**DOCKET 50-255 - LICENSE DPR-20 - PALISADES NUCLEAR PLANT  
RISK-INFORMED INSERVICE INSPECTION PROGRAM – RESPONSE TO  
REQUEST FOR ADDITIONAL INFORMATION (TAC NO. MB4420)**

**RISK-INFORMED INSERVICE INSPECTION PROGRAM  
RESPONSE TO REQUEST FOR ADDITIONAL INFORMATION**

Figure 1a: Diagnosis Dependency Decision Tree

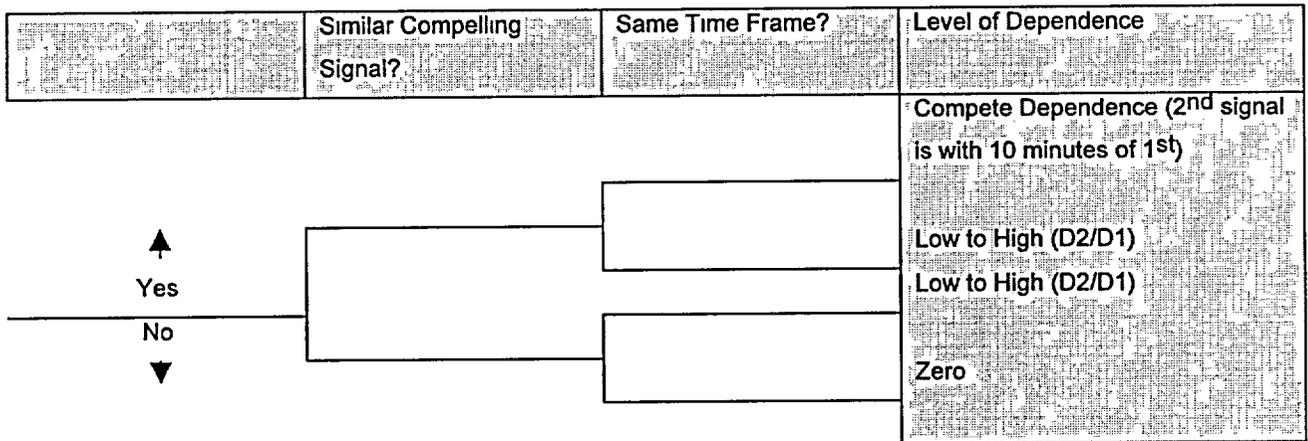
*Please explain how the incomplete review of dependencies could affect the evaluations performed in support of this relief request.*

The method consisted of the steps outlined below. The ASEP [1] and THERP [2] (THERP was used to identify the conditional dependencies in this evaluation, only) human error methodologies to assess and quantify dependent human error probabilities (DHEP) between the errors as shown in Figures 1a and 1b were employed. The human error dependency analysis consisted of the following steps.

3. Identify all post-initiating event operator error event combinations in the same CDF cutset in the baseline CDF equation.
4. Identify the combinations that are considered independent using the decision trees presented in Figures 1a and 1b.

6. Select several human error combinations that are not independent in accordance with Figures 1a and 1b and derive conditional values based on Figures 2a and 2b.
